39T-09501/OZ-7638  
Nancy Pasato

<b>TO:</b>	<b>CHAIR AND MEMBERS PLANNING AND ENVIRONMENT COMMITTEE</b>
<b>FROM:</b>	<b>GEORGE KOTSIFAS, P.ENG. MANAGING DIRECTOR, DEVELOPMENT &amp; COMPLIANCE SERVICES AND CHIEF BUILDING OFFICIAL</b>
<b>SUBJECT:</b>	<b>APPLICATION BY: EXTRA REALTY 660 SUNNINGDALE ROAD EAST (NORTHWEST CORNER OF SUNNINGDALE ROAD EAST AND ADELAIDE STREET NORTH)  PUBLIC PARTICIPATION MEETING ON JULY 22, 2014</b>

The purpose of this report is to recommend a redlined draft plan of subdivision containing 23 low density blocks, 7 medium density blocks, 4 commercial blocks, 3 open space blocks, 2 park blocks, 6 walkway blocks, 1 stormwater management block, as well as several 0.3 m reserves and road widenings, all served by one new primary collector, 2 new secondary collectors, and 4 new local streets.

**Figure 1 – Proposed High Density Residential Block and redline amendments**

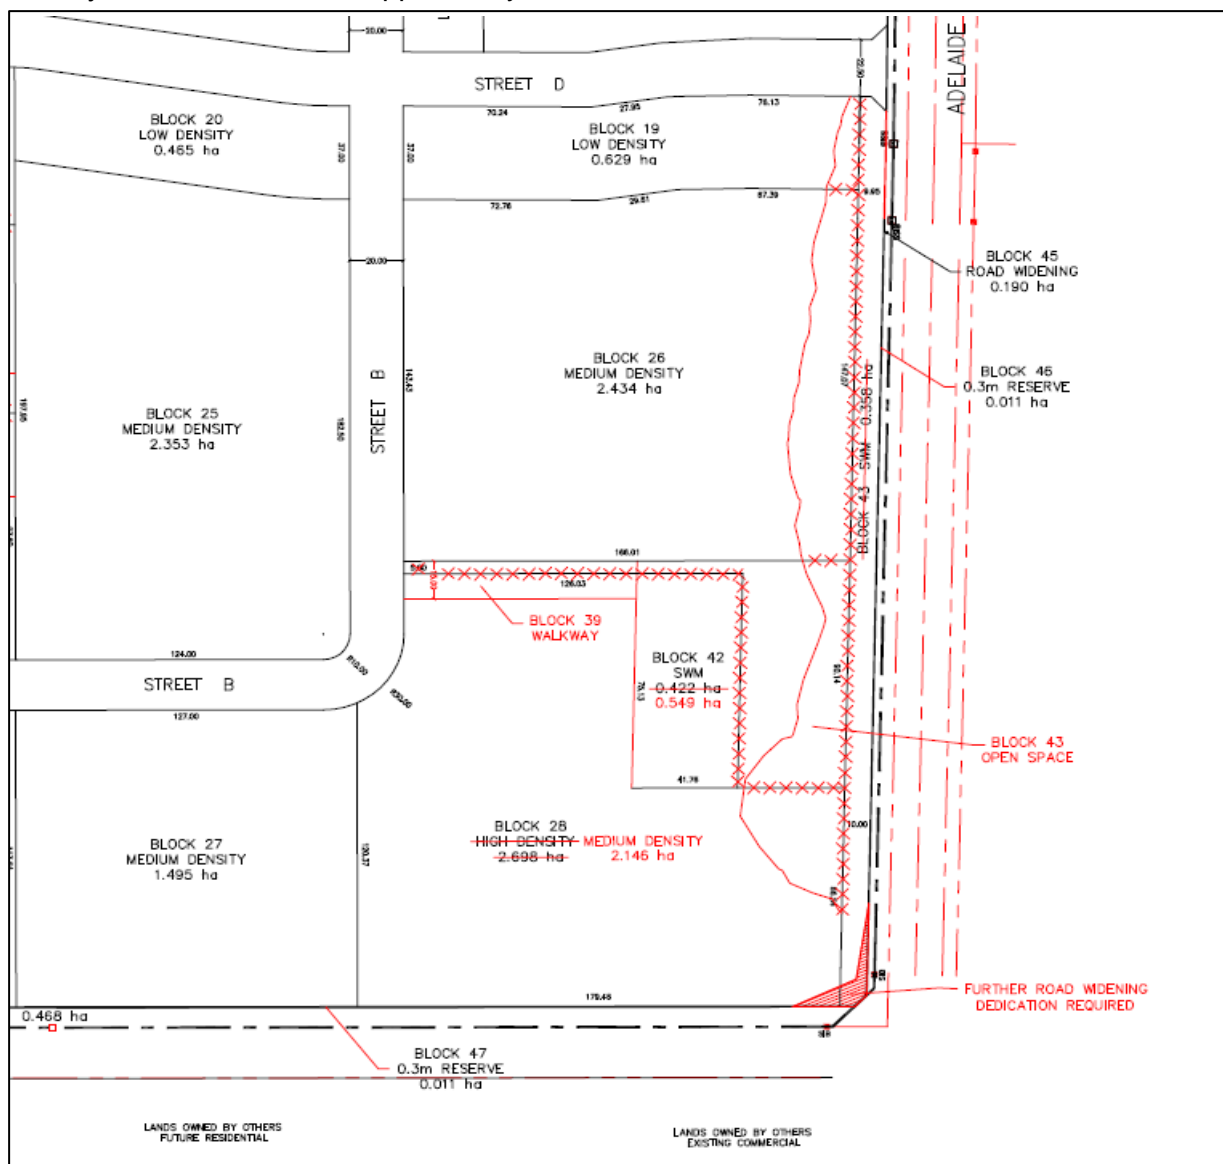
The requested change for Block 28 (located at the northwest corner of Adelaide Street and Sunningdale Road) from “Multi-Family, Medium Density Residential” to “Multi-Family, High Density Residential” is not supported by Staff.

The Uplands North Area Plan allocated approximately 5% of the total land area within Uplands North for high density development, and this was strategically placed at the Richmond and Sunningdale intersection at the principle northern entranceway into the City of London. While development is encouraged to achieve a more compact urban form (i.e. increased densities) in order to maximize the use of land and the investment in infrastructure, services and community facilities, the existing medium density designation still has the ability to develop at 75 units per hectare, with the possibility of achieving up to 100 units per hectare through the bonusing provisions of the Official Plan, and through design can still achieve a compact urban form. Recent applications in the area have increased density and height, but have still not achieved the height and densities requested through this application. Overall, Staff do not support the provision of High Density at this location, as it is not in keeping with the policies of the Official Plan for High Density, not in keeping with the Uplands North Area Plan, and is not a key location for higher density within the City.

Based on a review of the policies of the Official Plan, the recommendation for refusal of the proposed Official Plan and Zoning By-law amendments is supported by the following:

**Figure 2 – Previous commercial request from the Applicant April 2013**

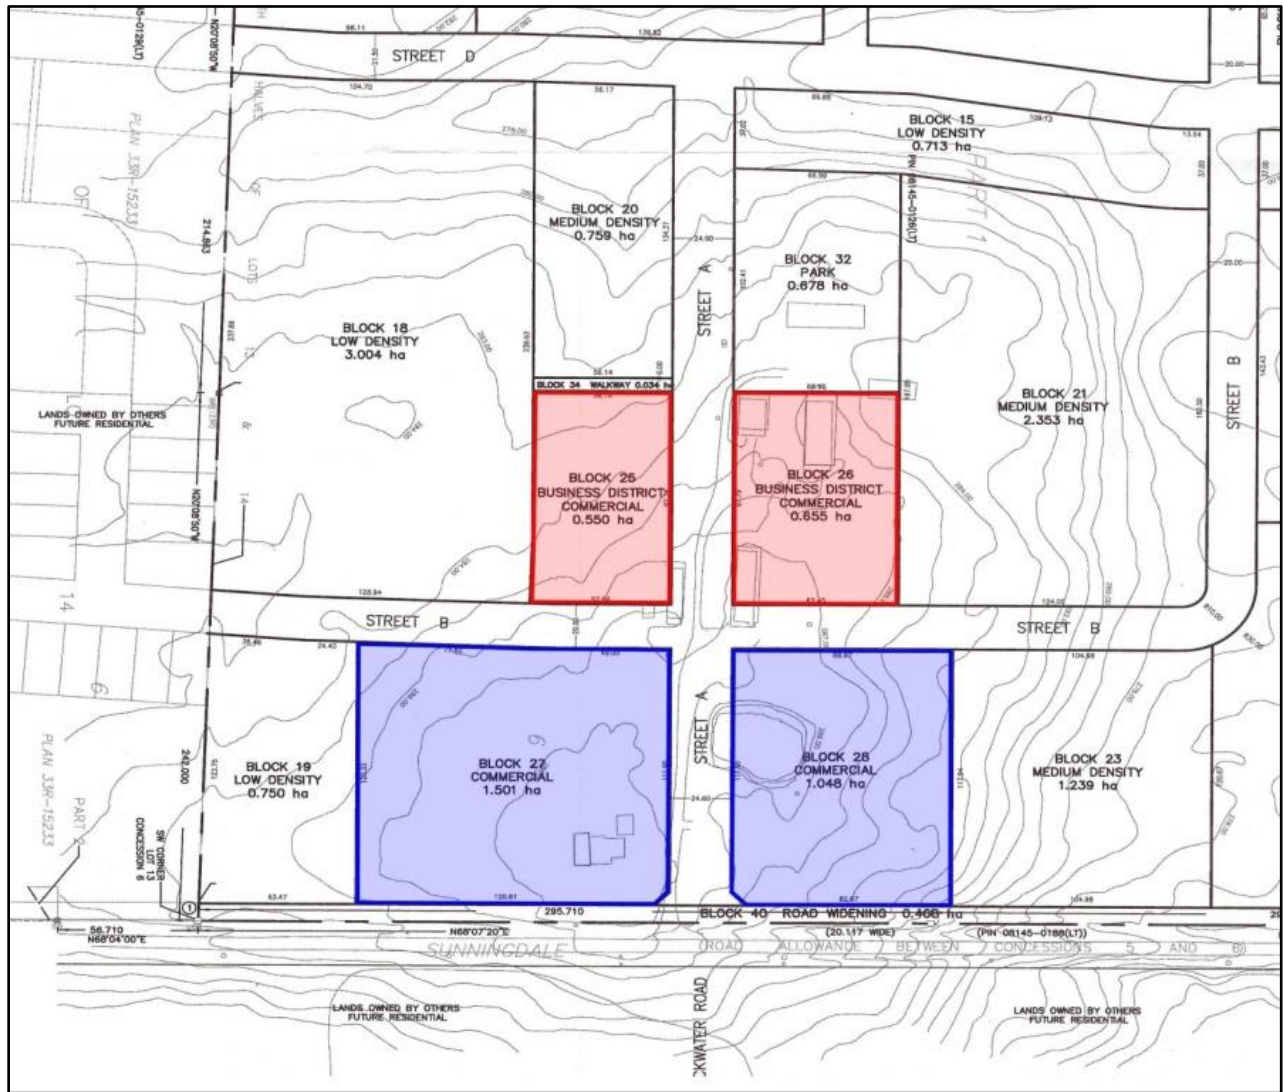
This most recent revised application provided by the Applicant has changed the configuration and amount of commercial. The Applicant has also submitted a concept plan for the commercial blocks (see Figure 3 – Commercial Concept April 2014). The Applicant has now requested the following:

Planning Staff are not supportive of the amount and type of commercial proposed through the plan of subdivision. The commercial justification study has provided certain assumptions to base its conclusions on that Staff do not agree with, such as the amount of commercial allocated per person in the subdivision (40 m<sup>2</sup> in the Uplands North Area Plan vs. 45 m<sup>2</sup> in the Commercial Justification Study), the parameters of the Trade Area used, and the importance of existing planned commercial already located and zoned in the immediate area. The report does not seem to address the immediate population and their local needs, but rather focuses on the larger area population. While commercial justification studies can be useful in establishing certain parameters around commercial uses, they are not the only consideration from a Planning perspective.

Figure 3 – Commercial Concept April 2014

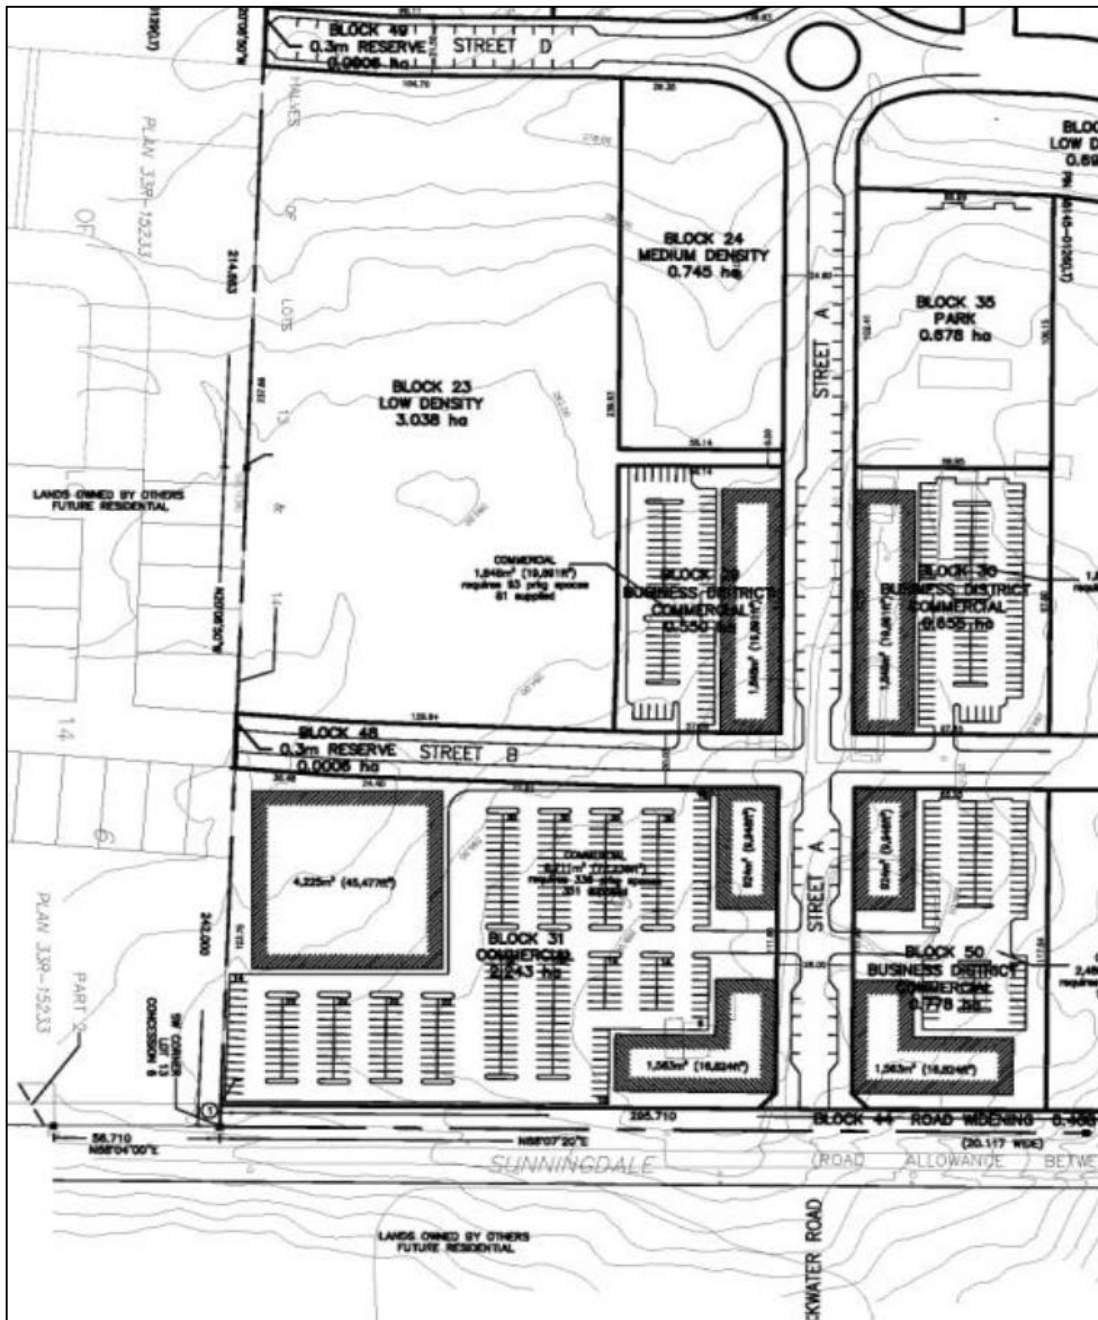
As part of the resubmission, the Applicant has submitted a Commercial Justification Study. This study has indicated that through this application, up to 13,400 square meters (144,000 square feet) of commercial space, composed of small scale retail stores, food stores, restaurants, offices and personal service establishments could be added to the area. The Commercial Justification Study indicates there is a need for a large amount of additional commercial facilities to serve the rapidly growing population in the northeastern portion of London. The study suggests that there is a need for an anchor tenant, such as a supermarket, in order for the development to proceed. A strong anchor tenant would provide a significant customer attraction to the site, which would in turn provide support for the other facilities planned for the development. The study also indicates that other facilities on the subject site, particularly the proposed Business District Commercial uses, are unlikely to develop as intended in the absence of a strong anchor tenant. In addition, the new commercial facilities proposed at the site would not negatively impact the existing or planned commercial space in the Trade Area, recognizing that existing and future population growth in the local area warrants a significant amount of additional commercial space.

**Figure 4 – Staff recommendation for commercial**

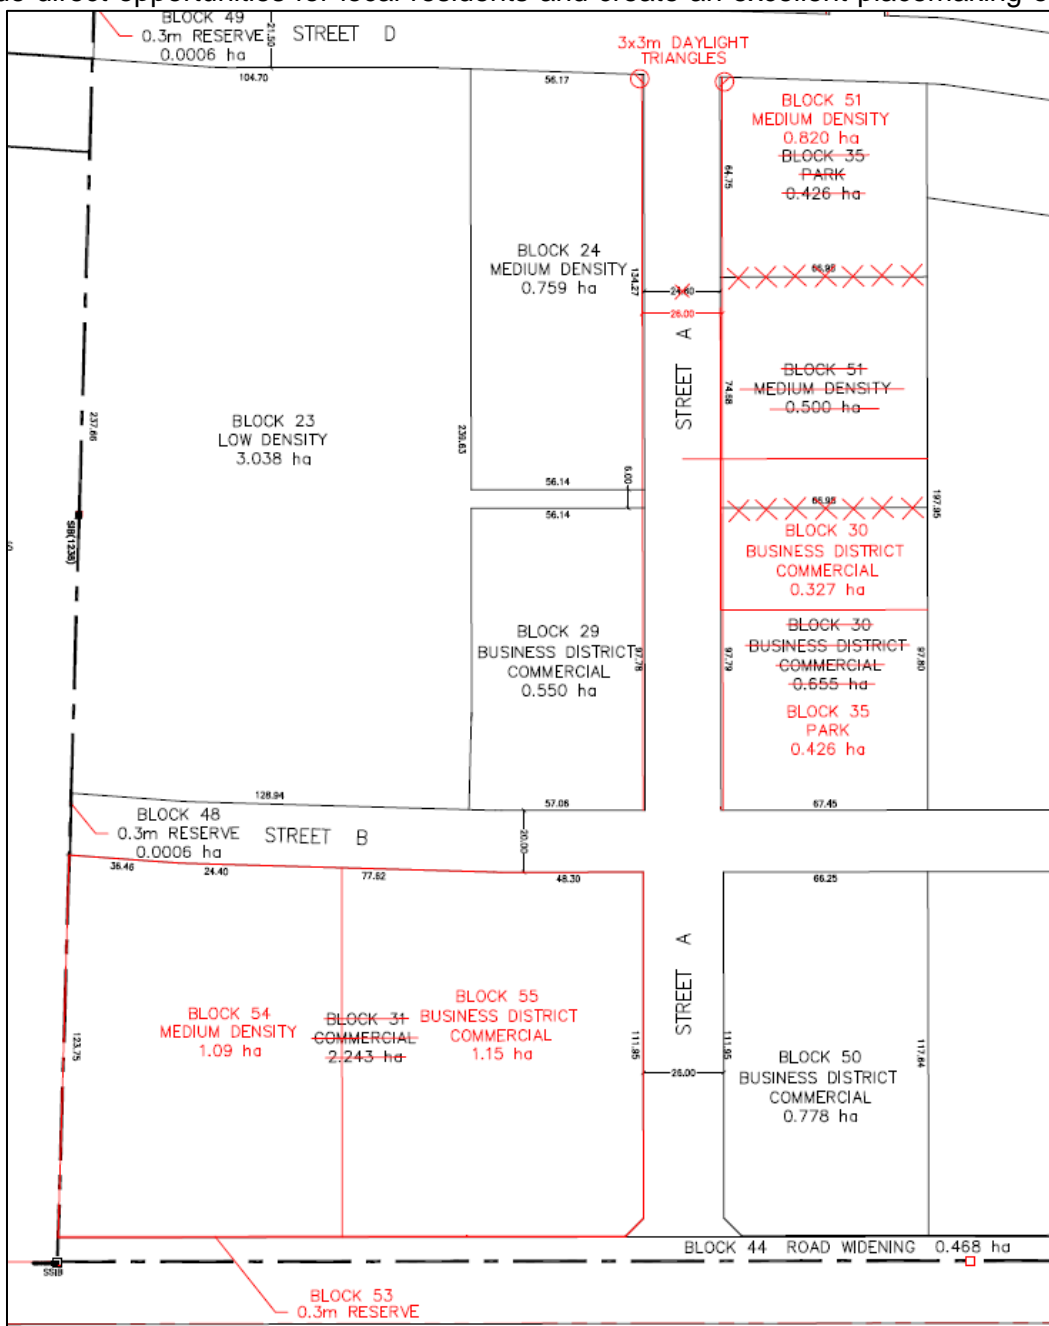
The Main Street Commercial designation is an appropriate commercial designation for this area. It encourages smaller scale commercial uses in mixed used buildings, achieves placemaking principles of mixed use development, encourages building form and design that is pedestrian oriented, and facilitates a wide range of small scale commercial and office/personal service establishments that are meant to fulfill the local needs of residents. Such a mix is intended to provide live-work opportunities and pedestrian accessibility to consumer goods and services within the area and the surrounding residential communities. An integrated design with a clear focal point and quality pedestrian linkages is intended to support walkability and a strong sense of place. It is recommended that Blocks 29 and redlined Block 30 would take the form of a mixed use building, with commercial/office uses restricted to the first floor, and residential units above. These would be limited to a maximum of 500 m<sup>2</sup> (5,382 ft<sup>2</sup>) of commercial/office uses on Block 29, and a maximum of 250 m<sup>2</sup> (2,691 ft<sup>2</sup>) of commercial/office uses on Block 30 (adjacent

to the park). Block 30 would also be redlined to half its previous size as a substantial amount of commercial north of the park and farther away from the intersection of Street A and B is not feasible. Both Blocks would allow a maximum height of 18 m, which could facilitate up to a 6 storey mixed use building. Design principles, such as minimum and maximum building setbacks, will be incorporated into the implementing zoning. For Blocks 50 and 55 (located at the south west and southeast corners of Street A and Street B and adjacent to Sunningdale Road), a more traditional commercial development has been recommended, still in keeping with the Main Street Commercial designation. These buildings will also be pedestrian oriented, but will not be required to be developed as mixed use buildings. These buildings will be limited to 3,000 m<sup>2</sup> (32,292 ft<sup>2</sup>) of commercial space on Block 55, and 1,000 m<sup>2</sup> (10,764 ft<sup>2</sup>) of commercial space on Block 50. In total, the four commercial blocks would allow for 4,750 m<sup>2</sup> (51,129 ft<sup>2</sup>) of commercial uses. This amount of commercial is small in scale, similar in principal to convenience commercial, while still allowing the Applicant to develop a small scale “anchor” tenant on the west side of Street A, in order to draw residents into the community and towards other commercial opportunities to the north. This scale will not detract from the larger scale commercial uses already planned in the area. The form and function recommended by Staff will provide direct opportunities for local residents and create an excellent placemaking opportunity

**Figure 5 – SWM Block (42) and Conveyance Channel (43), redlined**

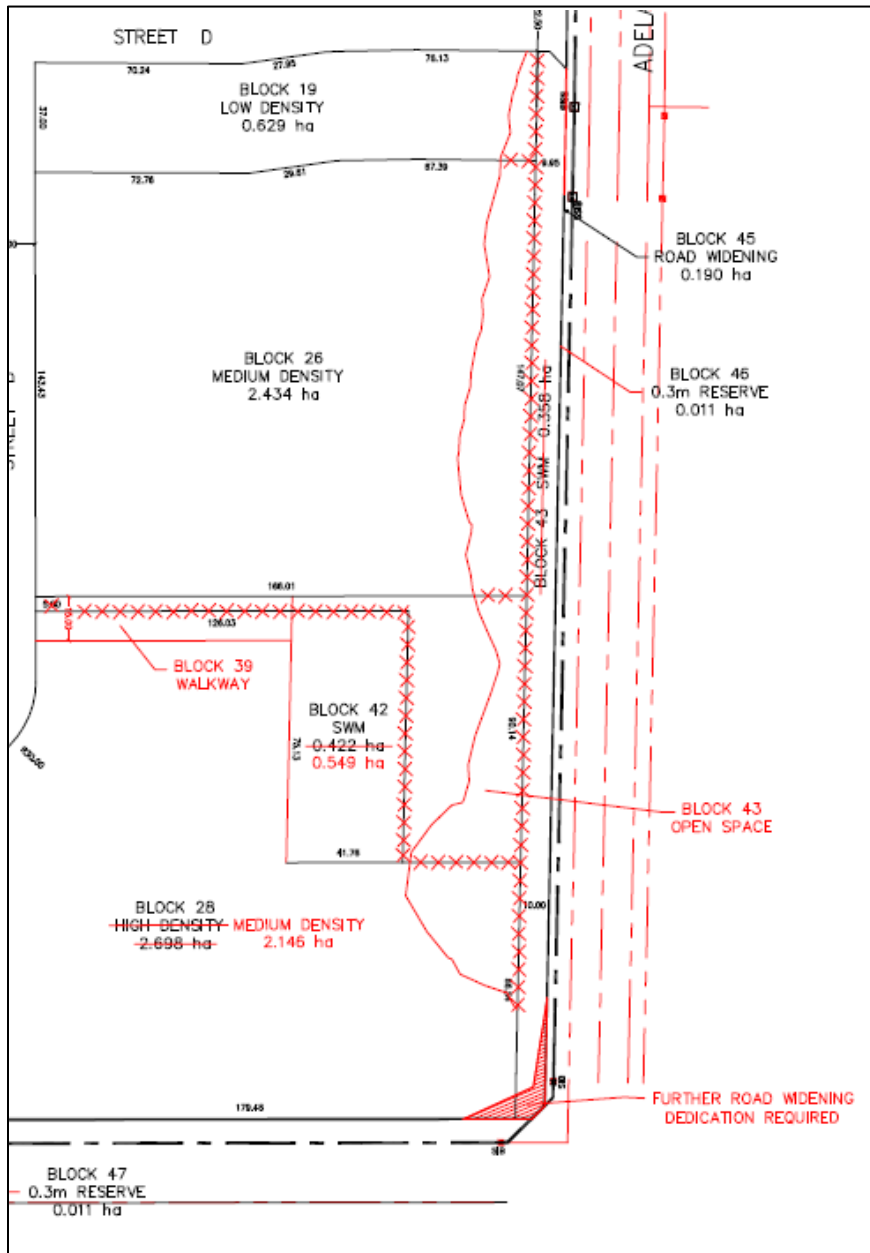
The Applicant has proposed a stormwater management pond (Block 42) and a conveyance channel (Block 43) as part of the stormwater management system. The Storm Drainage and Stormwater Management servicing for Stoney Creek Undeveloped Lands Schedule B Municipal Class Environmental Assessment (EA) had initially proposed the SWM pond directly adjacent to the PSW (Block 33); however, this scenario was not supported by Planning and UTRCA staff. The Applicant has submitted several iterations of the functional stormwater management servicing report over the last five years.

*“The UTRCA does not support the proposed realignment of the channel along Adelaide Street and advises that the existing configuration be shown on the plan.... Block 42 on the revised plan shows a proposed SWM block. The proposed SWM pond is within a regulated area and may impact the natural heritage and hazard features including a wetland and watercourse. Furthermore, the proposed SWM pond may increase the base flow into the wetland as demonstrated by the water balance analysis.”*

Staff have made a redline change to Block 43 to reflect the channel meander and include a 15 metre setback from the meander. This has also necessitated a redline revision to the stormwater management Block 42 as the stormwater management pond cannot be located within the 15 metre setback from the stream corridor. A condition of draft approval will ensure that once the functional design of the stormwater pond is acceptable, Block 42 may decrease in size. Any excess lands not needed for the pond may revert back to the Applicant. These changes may require a further redline amendment and may also require a Zoning By-law amendment.

Figure 6 – Redlined Draft Plan of Subdivision and Proposed Zoning

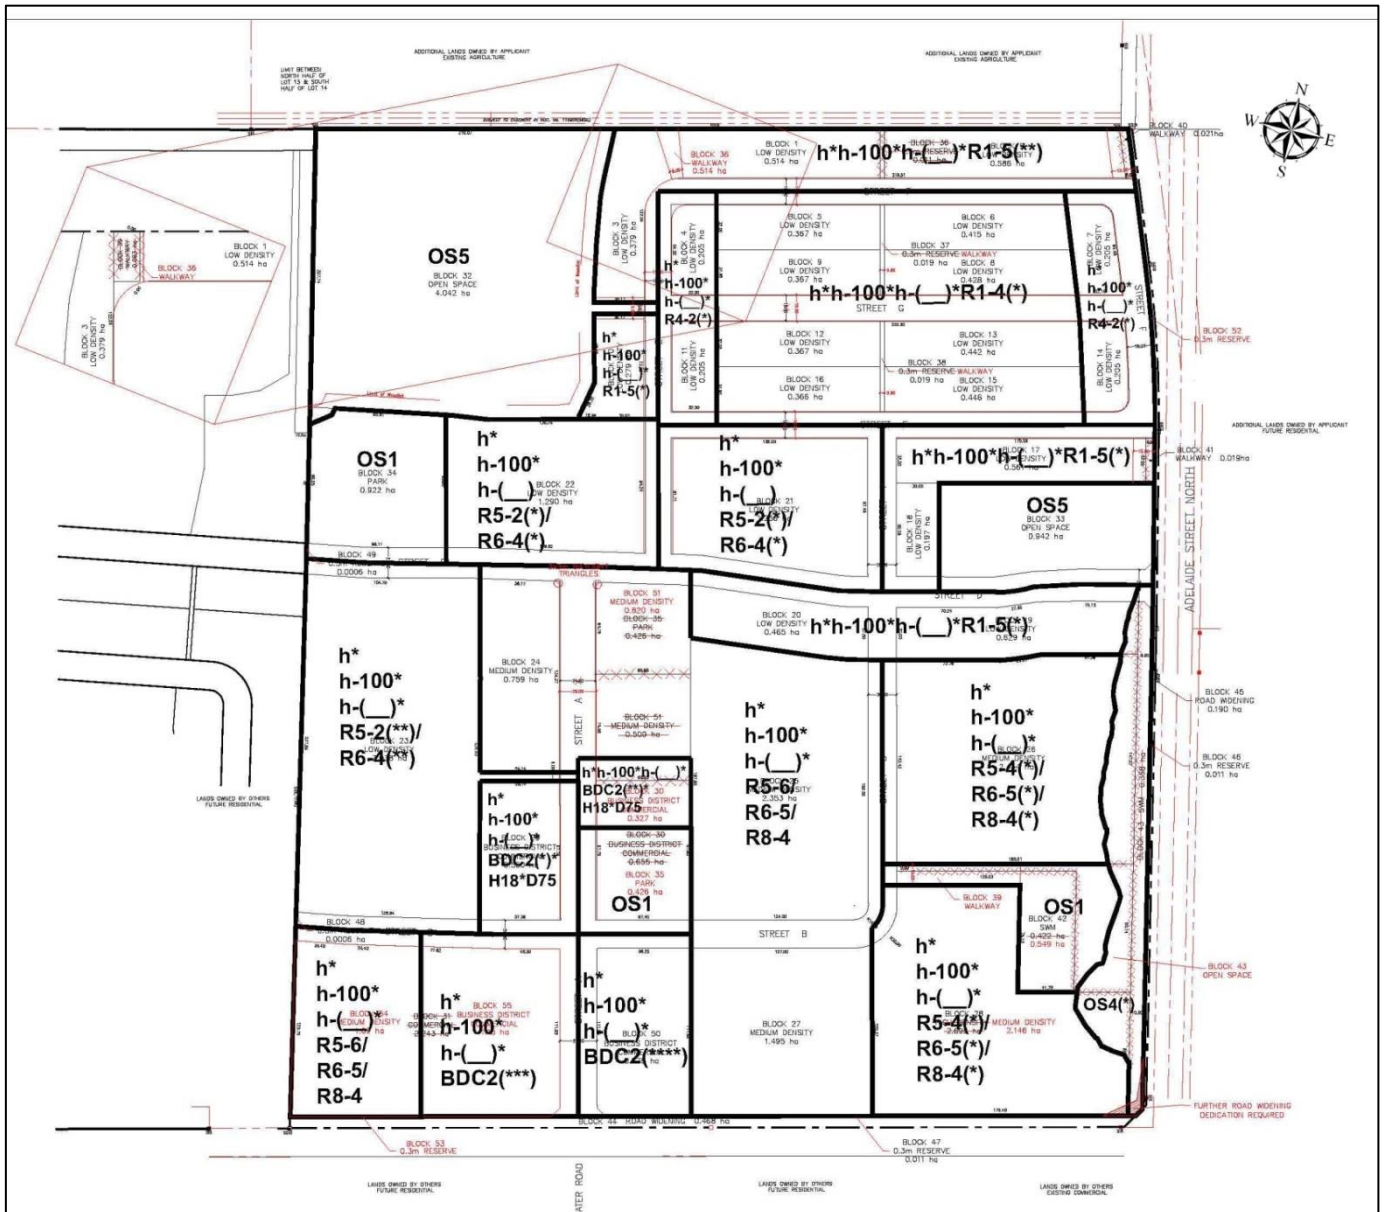
The Applicant had submitted 18 metre road widths through this section of the Plan. However, the standard road width for a local street is a minimum 19 metres and 20 metres for greater than 50 lots. Previous subdivision submissions included the use of rear laneways for the Blocks, which could warrant the reduction in street width to 18 metres, however, rear lanes are no longer proposed through this Plan; therefore the Plan will be redlined to include 19 and 20 metre road allowances. The window street, however, will continue to be 18 metres, as 18 metres is the standard for window streets in the City.
